Dear Reviewer,

The current manuscript is about an automated workflow between structural geological models and physics-based numerical models for evaluating structural uncertainties in HT-ATES. This workflow is tested on 2 examples: an example with variable reservoir thickness and an example of a wedging reservoir with a sealing fault zone. Of course, an automated workflow is of great importance for mesh-based simulations, as re-meshing can be avoided. Nevertheless, the applications should be chosen so that they are not just a proof of concept but can also be used for more sophisticated uncertainty analyses. In the applications presented, a variation in the thickness and position of a sealing vertical fault zone within a thinning geological layer was evaluated. This is a good start but currently seems to be the limit of the method used. Furthermore, only 3 cases were calculated for the first reservoir and only 17 cases for the 2nd reservoir, which is the lower limit for an uncertainty analysis. The content of the manuscript is adequate for GMD, but major corrections are required in order to accept the manuscript.

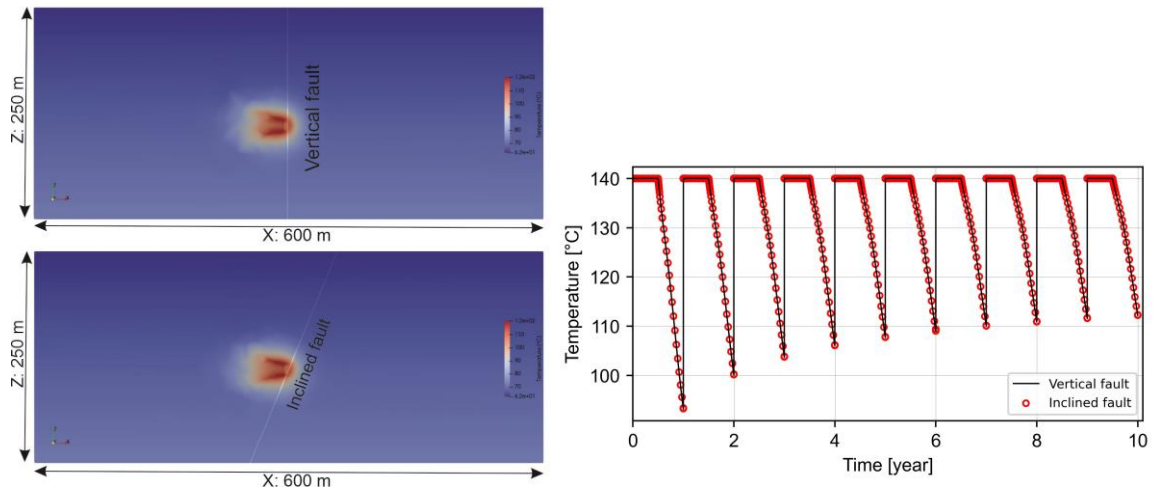
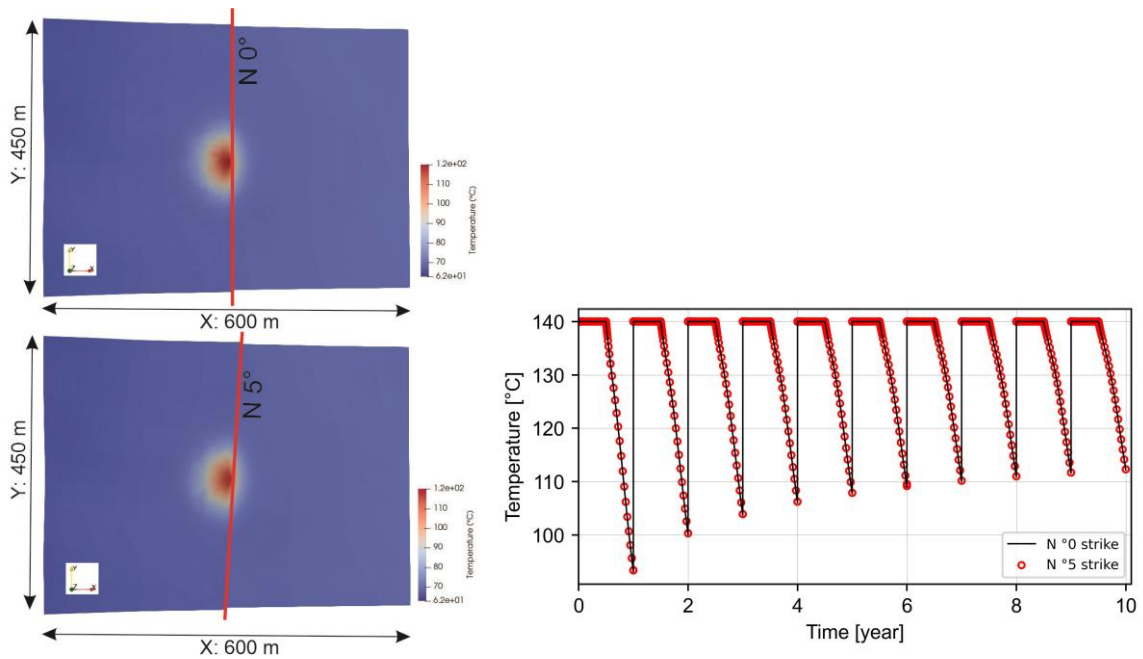
P5L127: A normal fault with a vertical offset of more than the reservoir thickness is presented. Main question is, what is the stress state to generate a normal faulting with such an offset? Generally, normal faults dip with 40 to 70 degree.

P6L151. One more, the normal fault is represented as vertical fault. Is this a limitation of the method? How dip and dip-direction are quantified. If no quantification was made, dip and dip-direction should be analyzed in the uncertainty study.

For the sake of comparison, two new special fault models including a fault of 67° dipping angle or $\pm 5^\circ$ strike angle have been elaborated and tested against the existing vertical scenario. The comparison was made on the example of the vertical fault in Chapter 3.2 (i.e. fault located 4 m in the east of the well). The following figures show the results in two cases that look almost the same:

Comparison of vertical to 67° inclined fault: figures (left: contour plot of temperature after 10 years i.e. the last production cycle, right: well temperature over time) show a nearly perfect agreement of both cases, i.e. vertical versus inclined fault.

Comparison of vertical to $\pm 5^\circ$ deviated fault: figures (left: contour plot of temperature after 10 years i.e. the last production cycle, right: well temperature over time) show a nearly perfect agreement of both cases, i.e. N 0° versus N 5° fault.

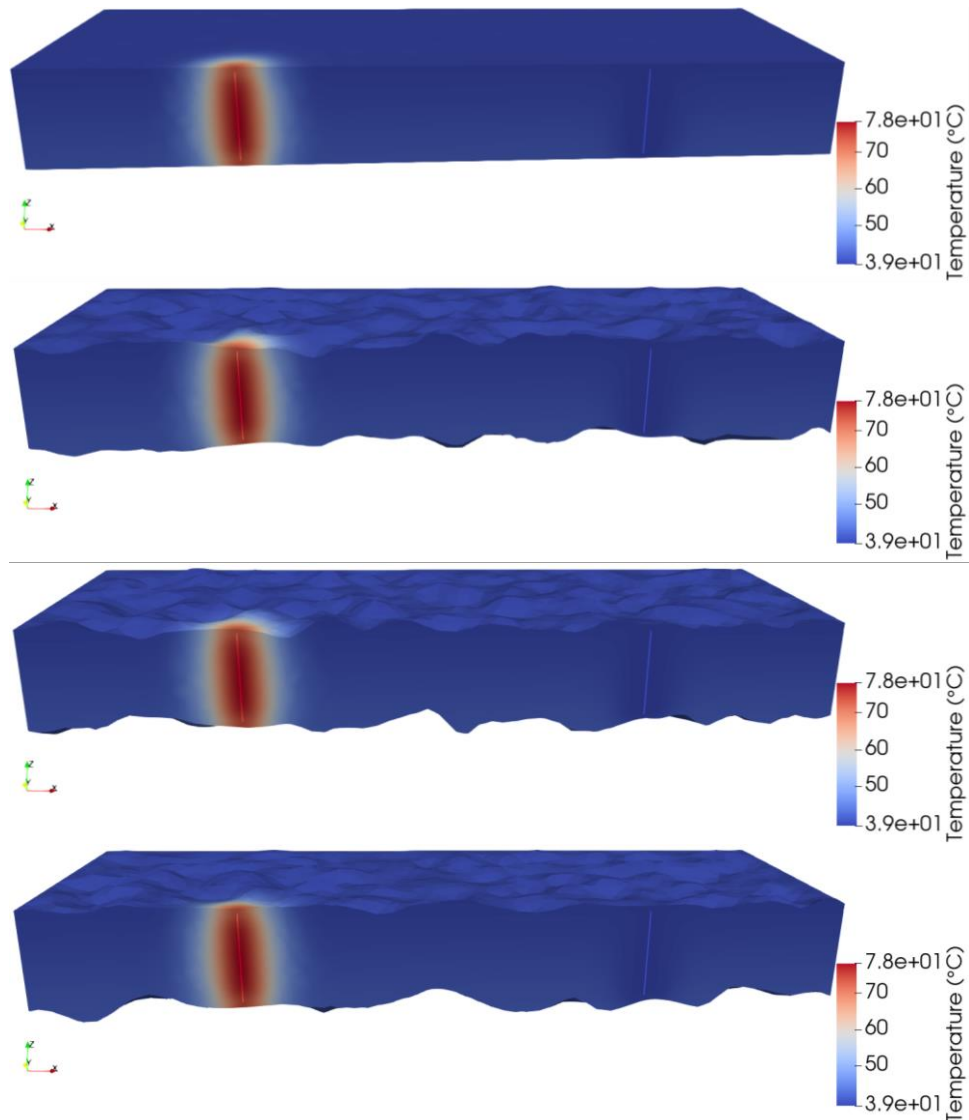
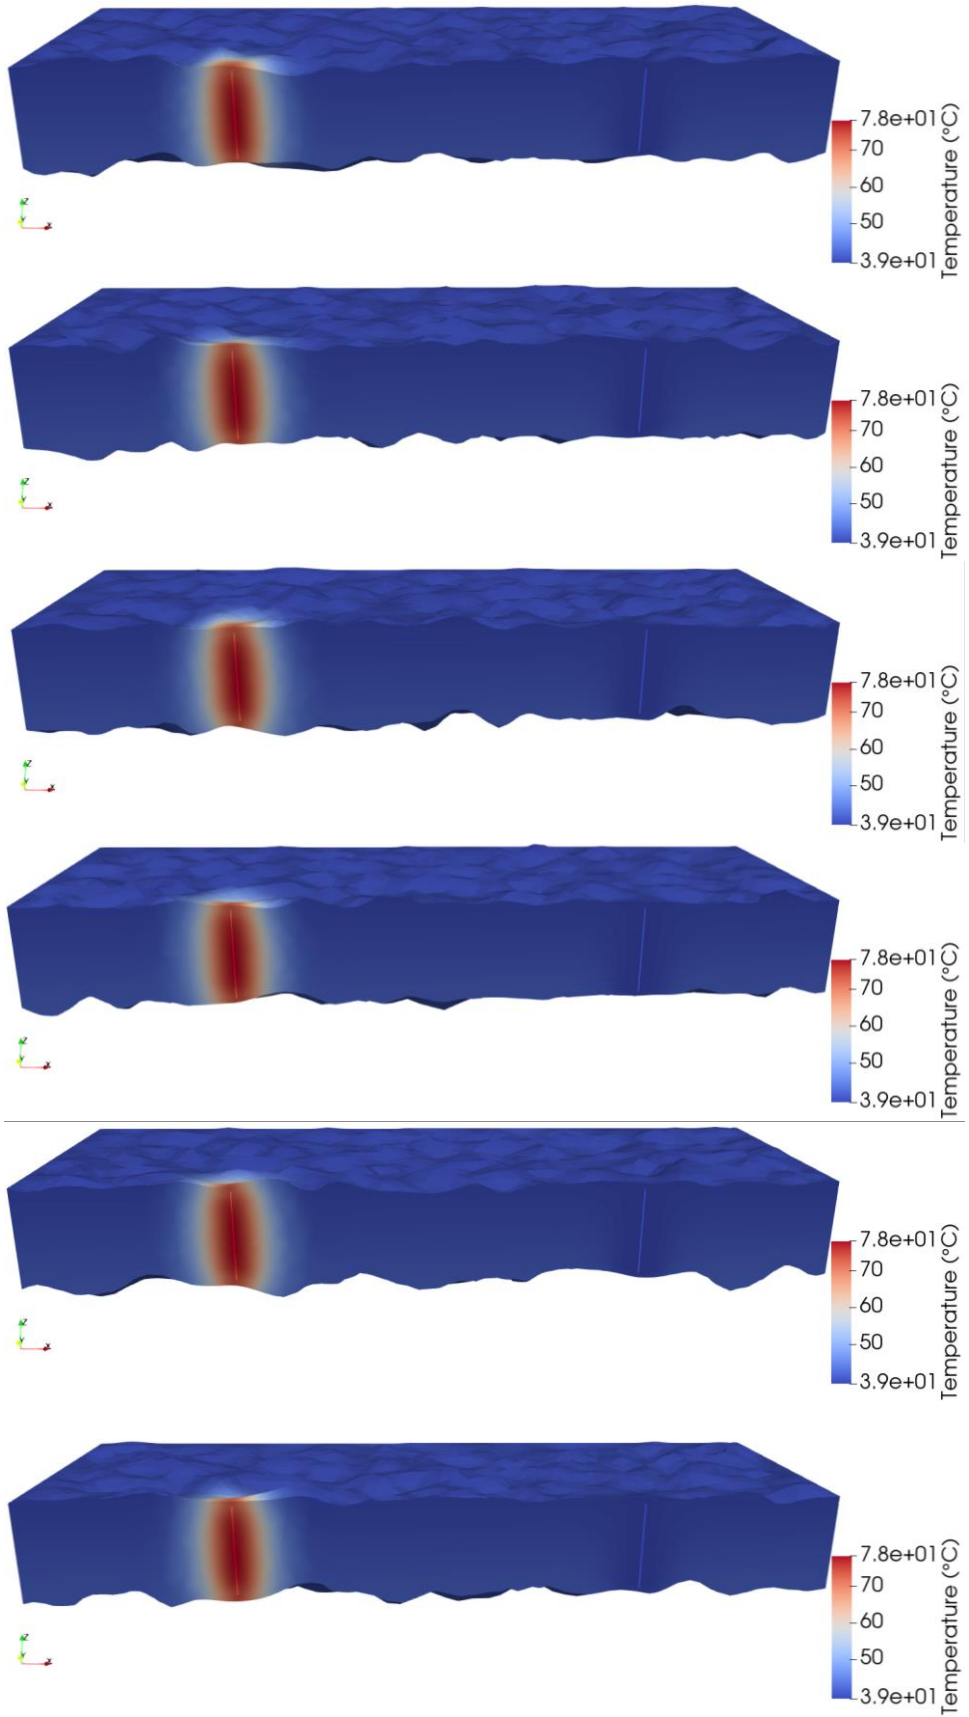
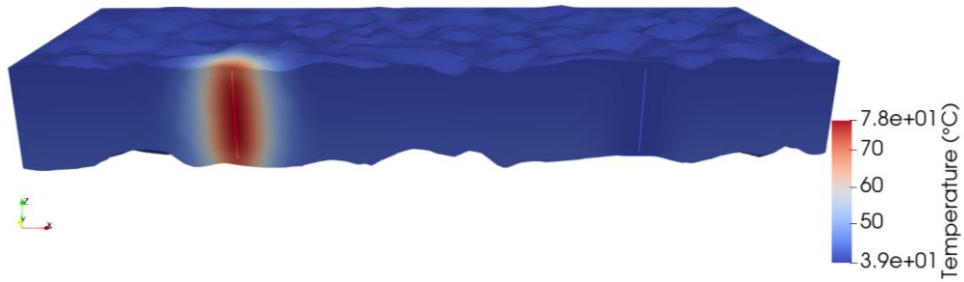
P6L152-155: As mentioned before only few scenarios were considered for this uncertainty analyses. One advantage of the automatized workflow should be the performance. Why not thousands of simulations were performed for varying distances, strike directions and dip angles?

- B) The following provides an example of the unlimited application of the code regarding the number of scenarios for the Greater Geneva Basin (GGB). The final resulting storage capacity (temperature production) does not vary and was therefore not presented in the manuscript. For further illustration, we uploaded examples of 101 surfaces ready to be meshed and - due

In the manuscript, we generated the arbitrary (generic) geometries by adapting the top and bottom surfaces of the reservoir. Out of 11 simulations, three had been presented in the manuscript. As discussed the reservoir performance is independent of the considered uncertainty on that scale. This result is later used in Chapter 4.1 to design an efficient exploration campaign for cases similar to GGB. The following illustrates this statement for 11 scenarios on behalf of the temperature field (after 10 years, i.e. the last production cycle) in the Malm reservoir. The different reservoir geometries are visible by their surface topographies, but they do not have any impact on the temperature field:

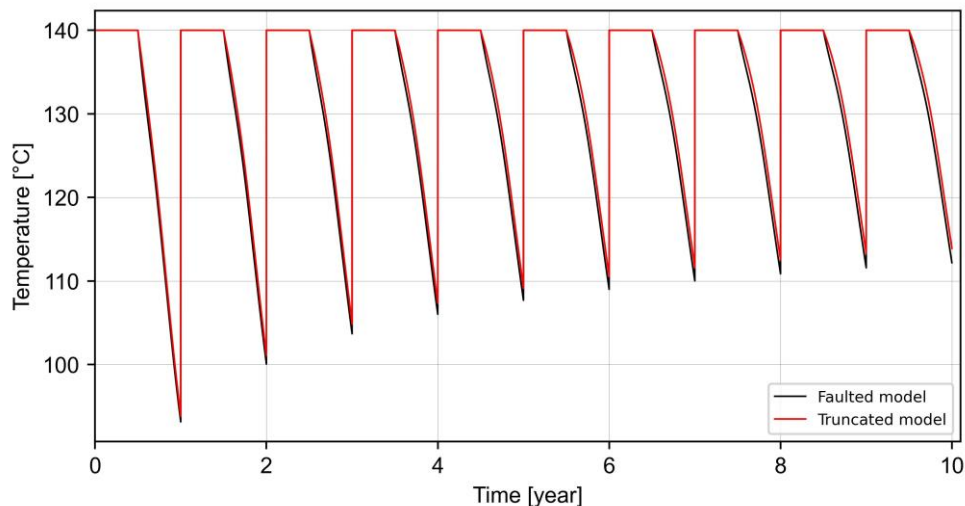
P6L145: The sealing fault is represented by an offset exceeding the thickness of the aquifer. To mimic the sealing fault this could even be done by truncating the model at a designated distance. I believe it is worth to check if a truncated model (at the distance of the sealing fault) would provide the same result as the model with fault offset. This could be a discussion point.

Thank you for bringing up this interesting point. Truncating the model can lead to higher temperature values within the model. As shown in Figure 8-b, heat diffusion occurs through the fault plane, potentially influencing the overall temperature distribution. Additionally, truncating the model may introduce boundary effects that could impact the thermal and hydraulic performance of the system during injection/production operations. We investigated this approach for one of the cases and examined the performance difference between a model with a fault located 4 m east of the well and a truncated model. As evident in the following figure, the truncated model exhibits a higher efficiency compared to the faulted model.

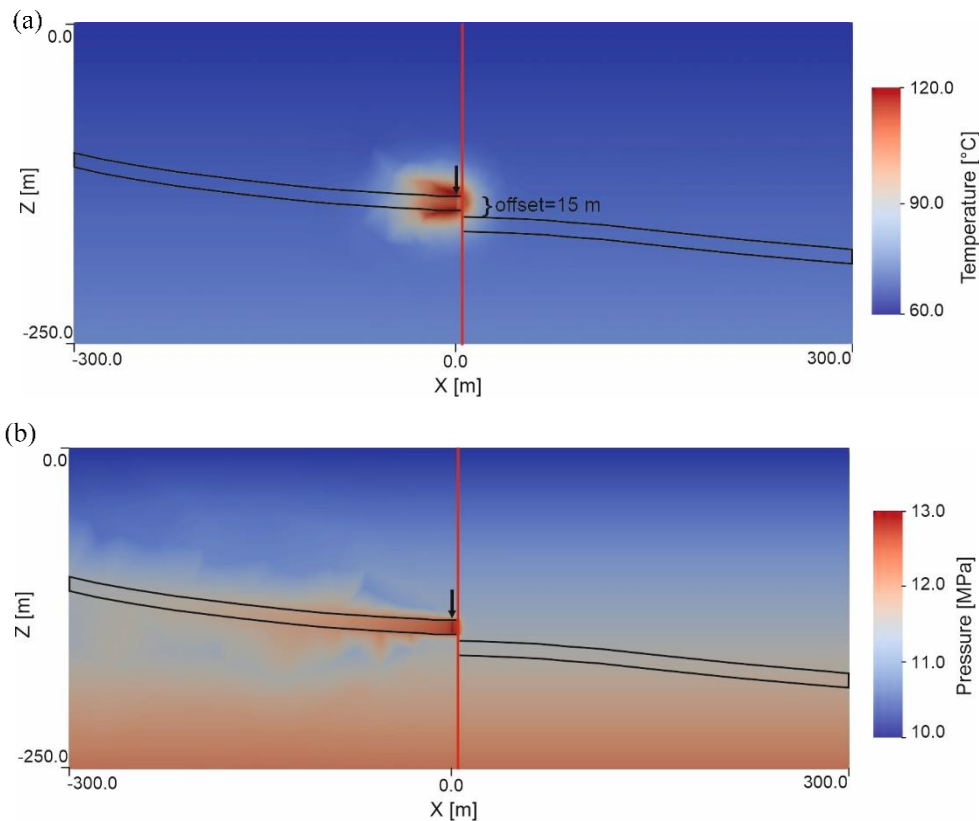
Figure 7: What is the vertical offset of the fault for these scenarios. It is mentioned to be more than the aquifer thickness. Why we do not see a sub-figure of such a simulation. I suggest to add a figure showing at least one example of the reservoir with fault offset and the related pressure and temperature field. In figure 8 the fault is visible but not the offset. Maybe this figure can be improved by showing all geometric features.

The vertical offset is 15 m. It is mentioned more explicitly in the updated manuscript. It was impossible to visualize the offset in Figure 8. Hence, a new figure (as Figure 10) is added in the Chapter 3.2:
